Village of Grantsburg

Village Board Meeting Agenda Monday, February 9, 2026 at 4:00 p.m. Village Board Room, 316 S. Brad Street

RE: Change Order 01
Village of Grantsburg
Grantsburg WWTP Improvements
SEH No. 184139 71.50

Change Order No. 1 to the Grantsburg WWTP Improvements project is enclosed. This Change Order includes six (6) items previously approved as individual line items by the Village Board and two (2) items that have not been approved. SEH recommends approval of Change Order No. 1 to incorporate the following changes into the Contract with Market & Johnson, Inc. (Contractor):

20 - WWTP SITE PLAN

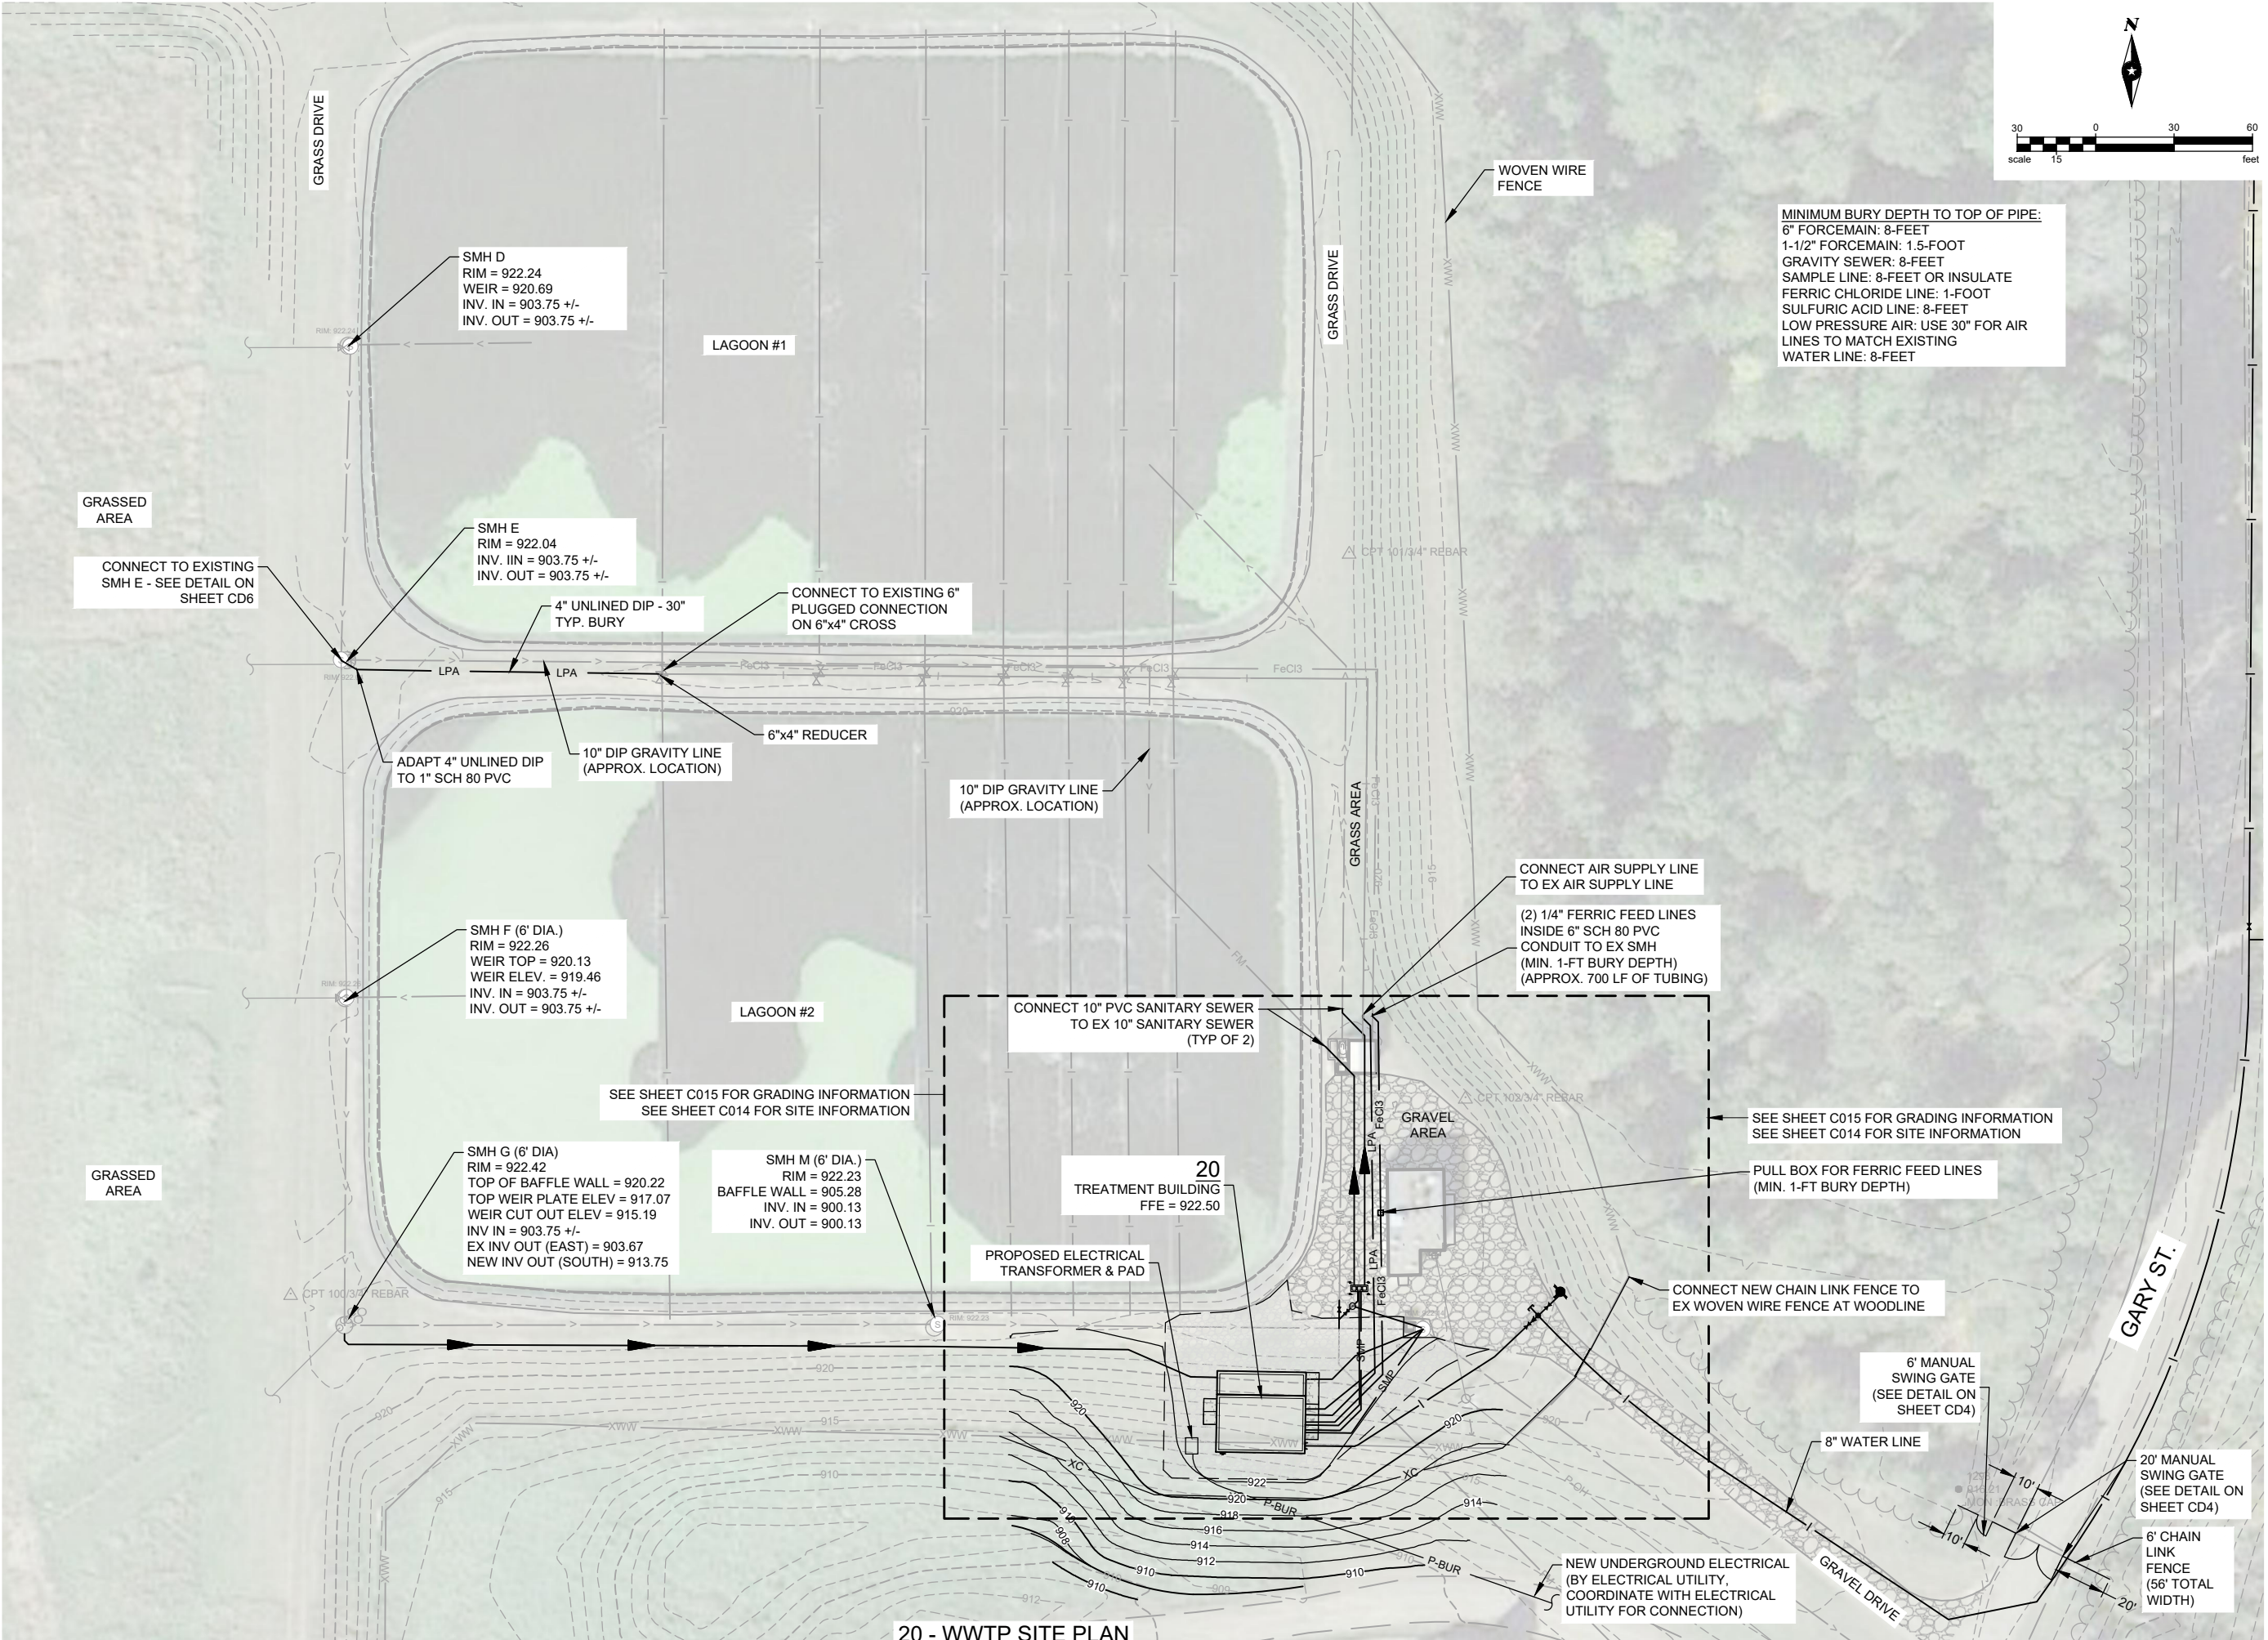
- **Change Order Request #05 – Building 20 Relocation (Field Order #3)**
The 10-foot south shift of the main WWTP building carries no cost impact and no change to Contract Time; COR #05 is recommended for approval. This change was approved by the Grantsburg Village Board on December 8, 2025.

1
S101
UV CHANNEL PARTIAL PLAN
1/4" = 1'-0"

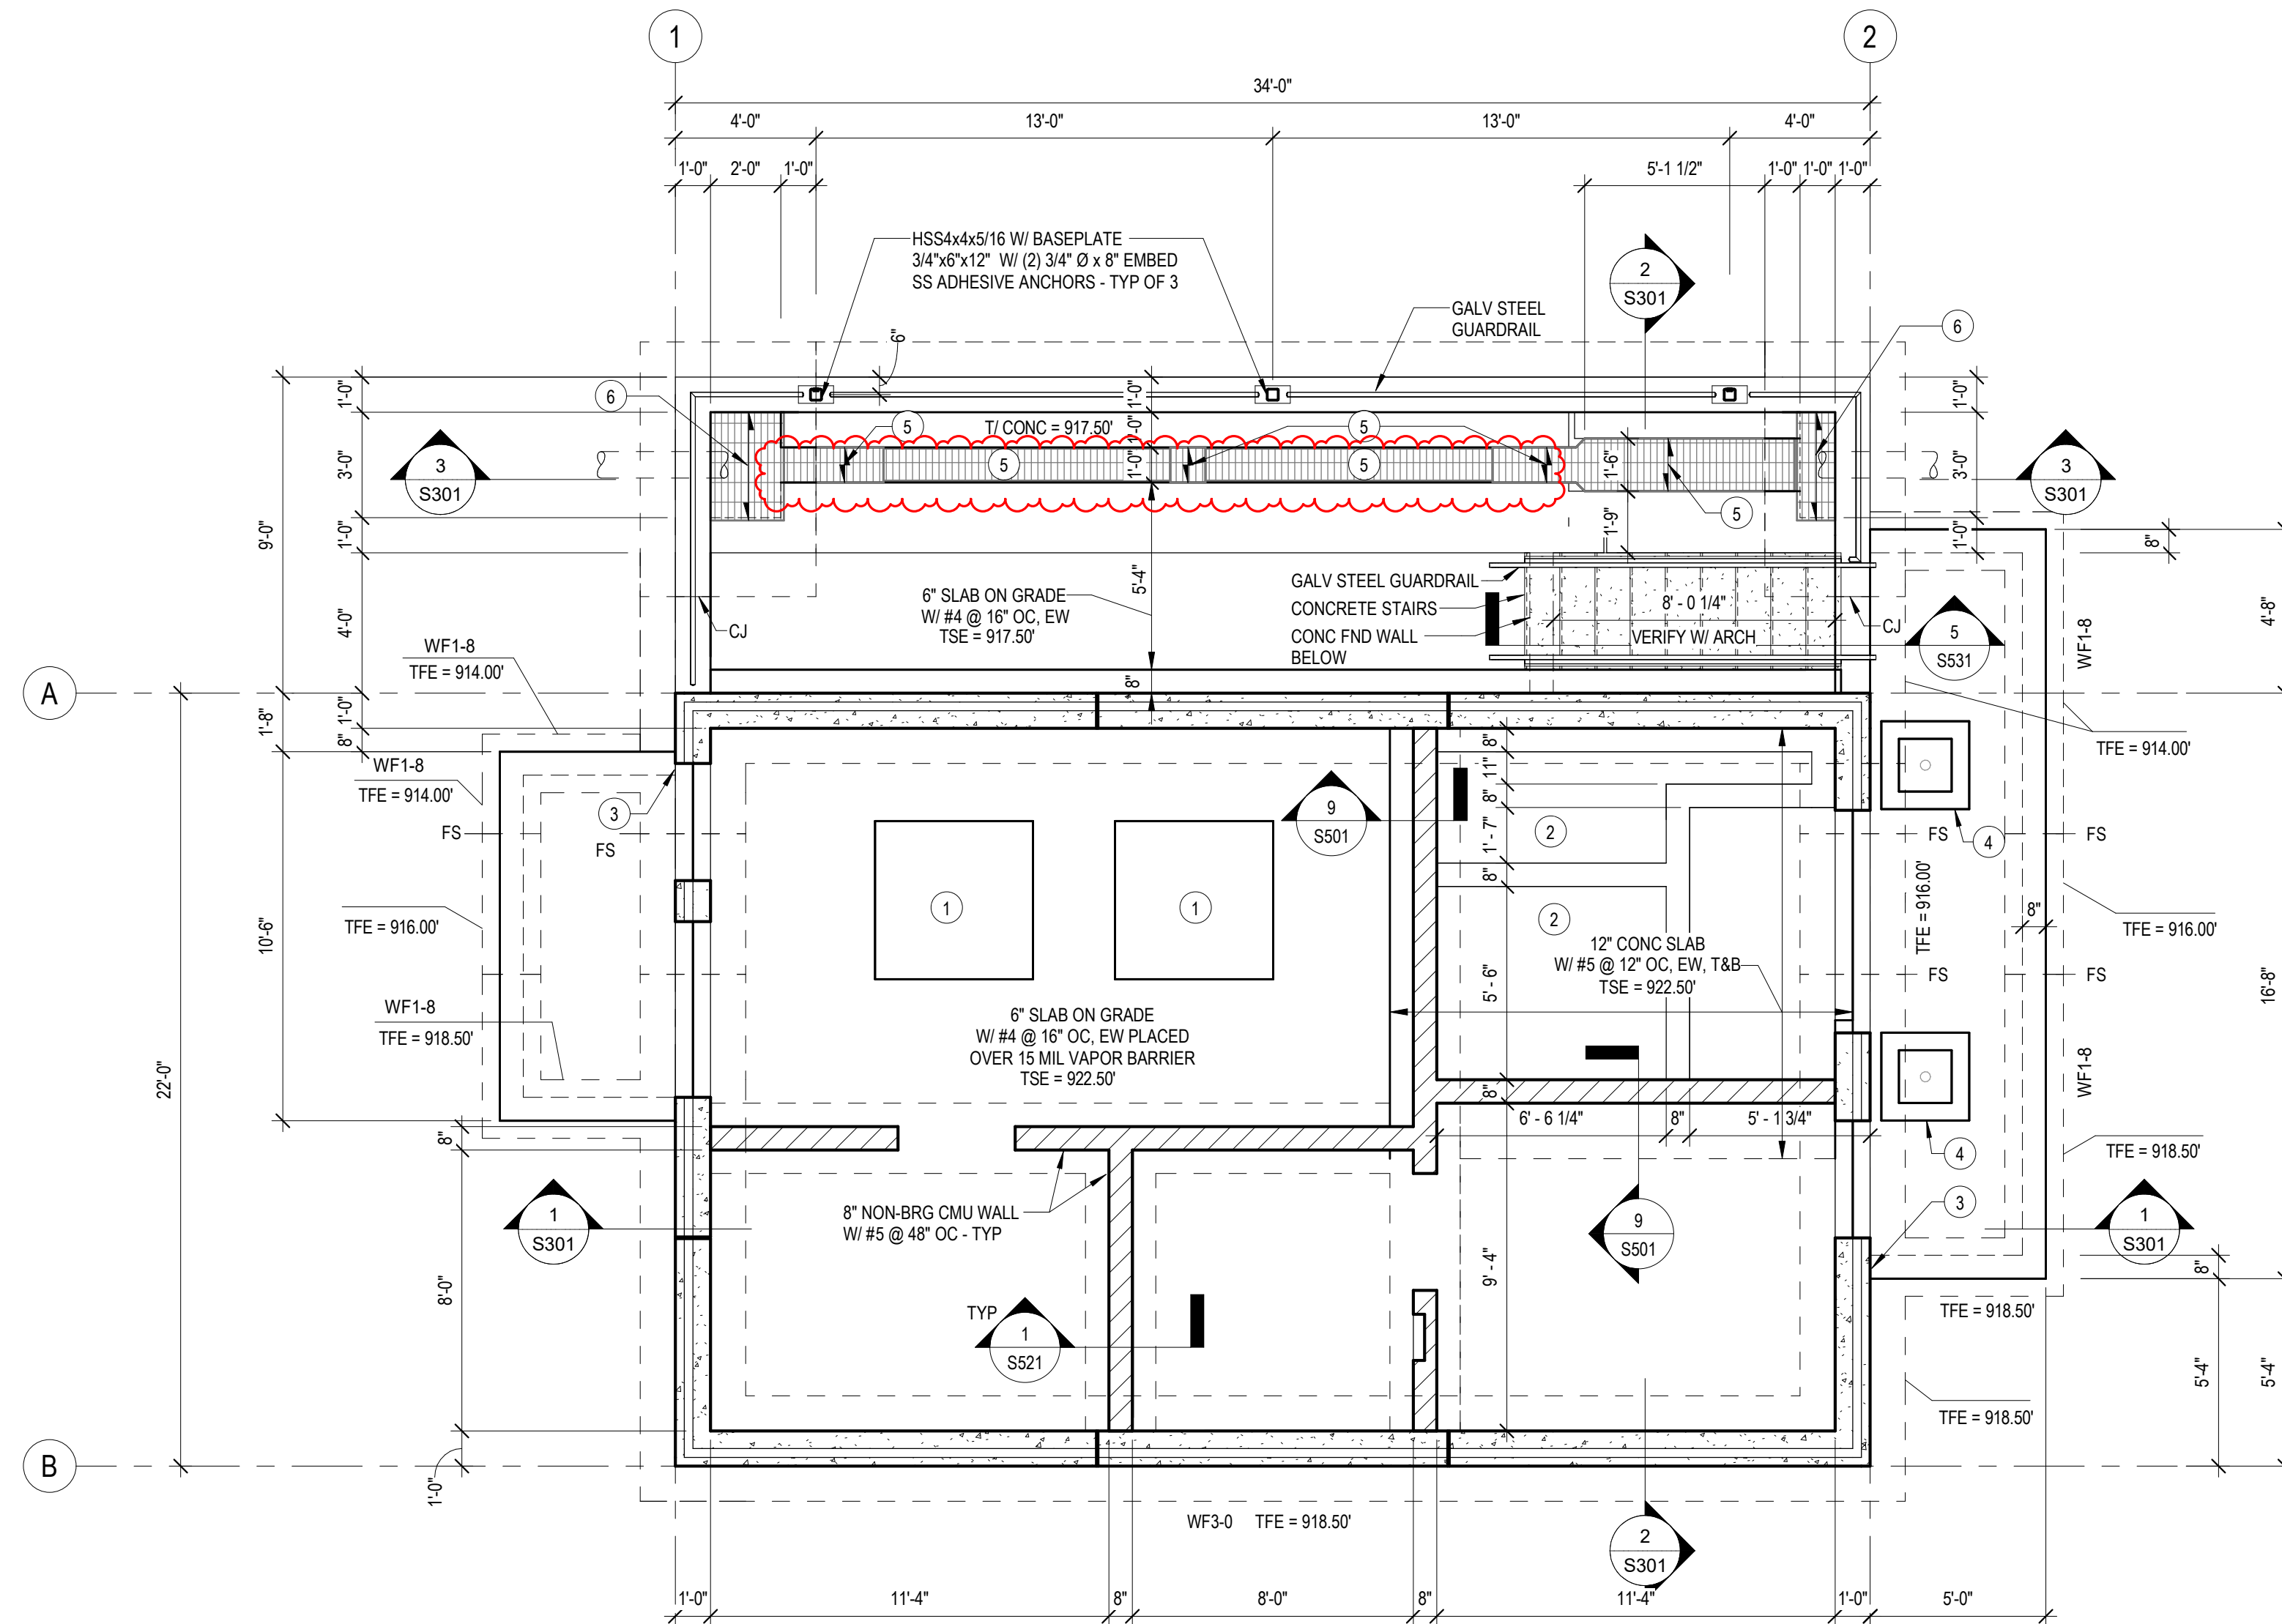
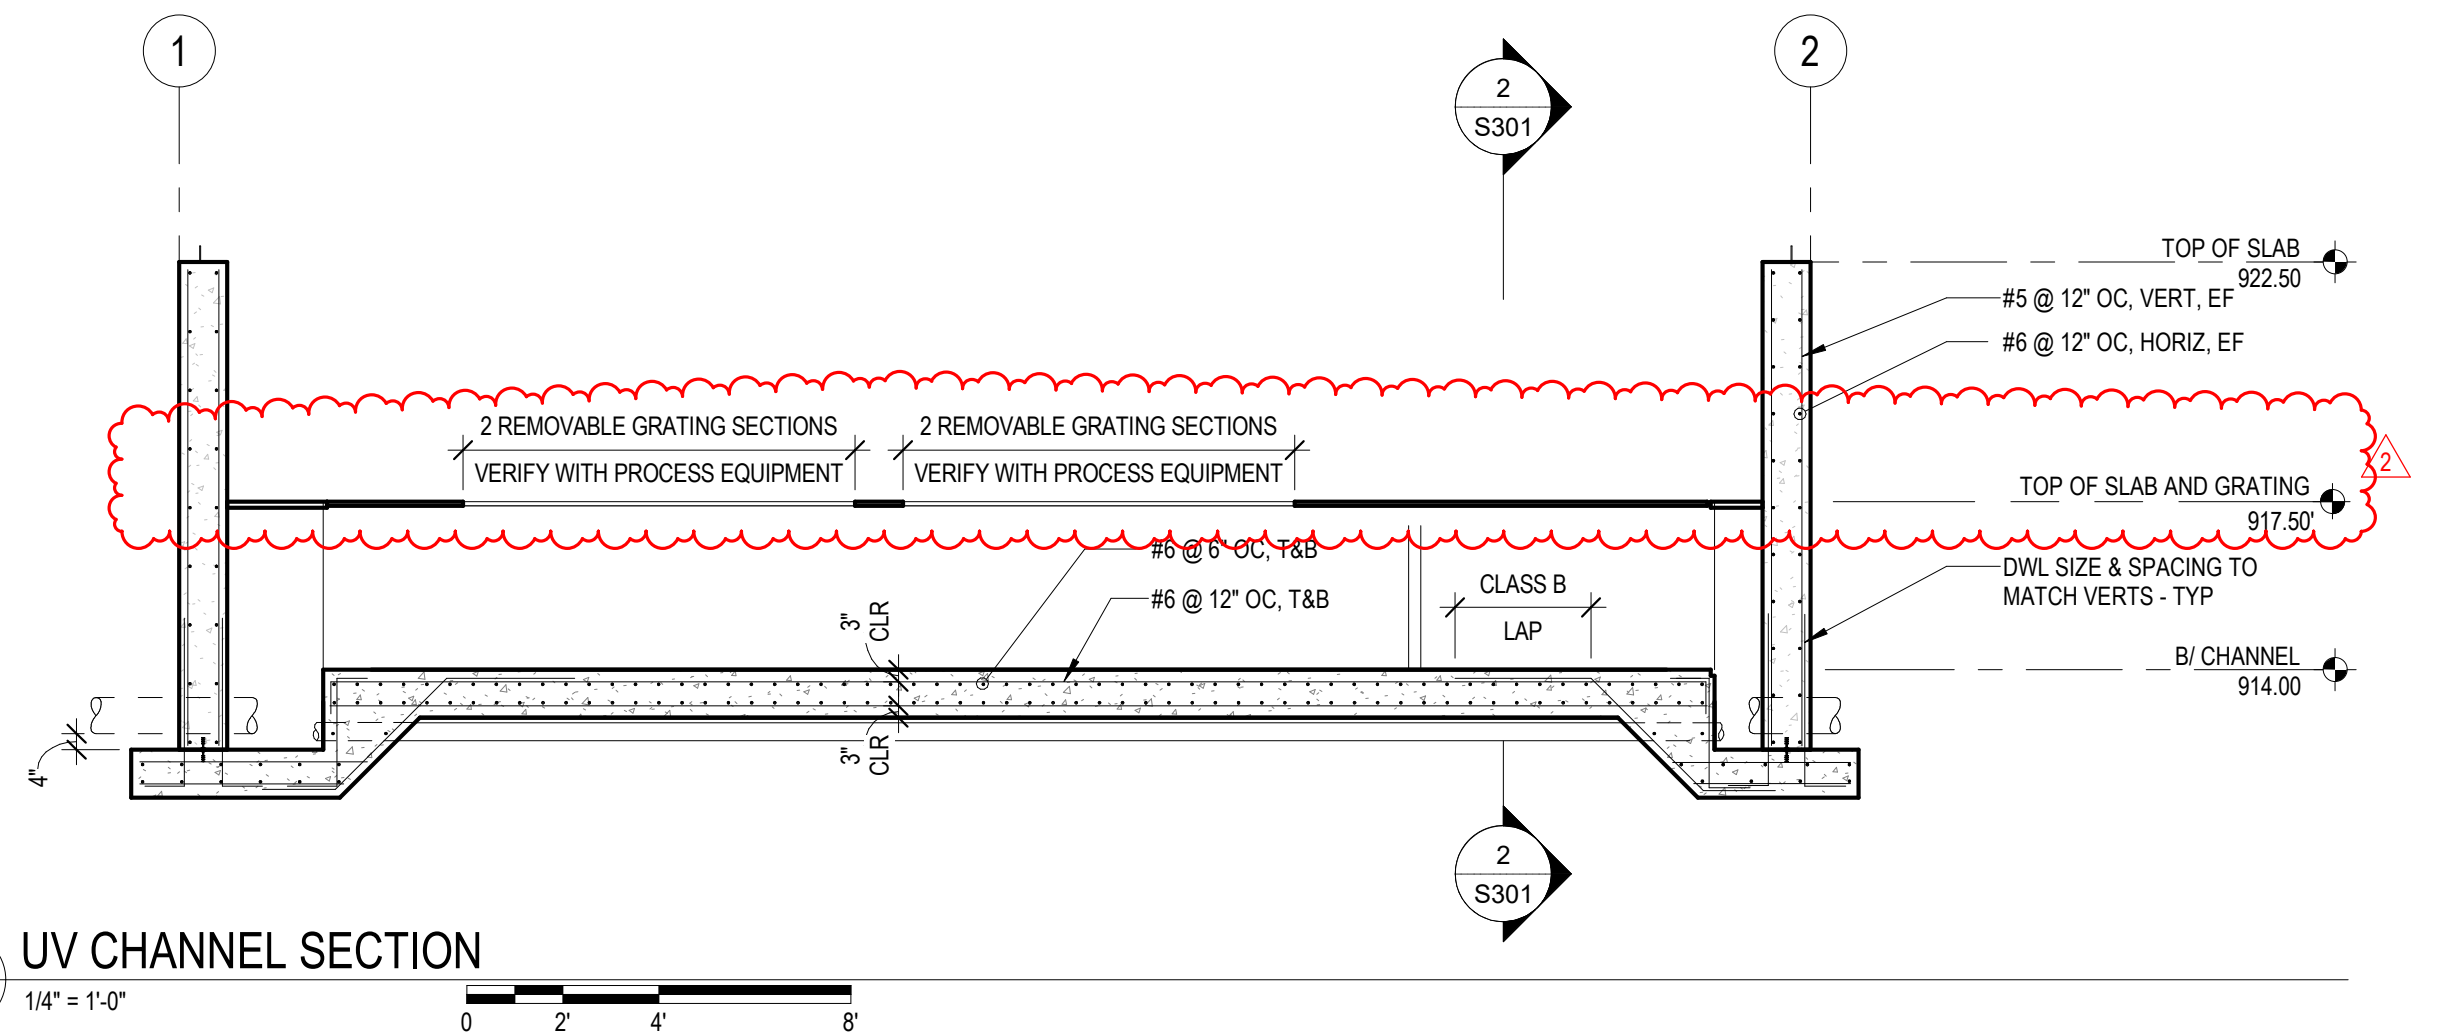
- Change Order Request #06 – UV Channel FRP Grating Modifications (FO #4)**
 Additional FRP grating materials are required to align with the UV equipment mounting details and to cover grating areas that were not fully defined in the original contract documents. The change amount of \$2,112.86 is recommended for approval, with no change to Contract Time. This change was approved by the Grantsburg Village Board on December 8, 2025.

We will go ahead and ask drafting to add these grating areas and embeds to the drawings.

- 1" FRP GRATING. GRATING DESIGN AND CONNECTION BY SUPPLIER'S ENGINEER. COORDINATE EXTENTS WITH PROCESS DRAWINGS AND APPROVED UV EQUIPMENT SUBMITTALS - SEE DETAIL 3/S531.

- 1 1/2" FRP GRATING. GRATING DESIGN AND CONNECTION BY SUPPLIER'S ENGINEER. COORDINATE EXTENTS WITH PROCESS DRAWINGS AND APPROVED UV EQUIPMENT SUBMITTALS. SEE DETAIL 3/S531 (TYP.) & 4/S531 WHERE WALLS CONTINUE UP (LEDGE IN CONCRETE NOT VIABLE).
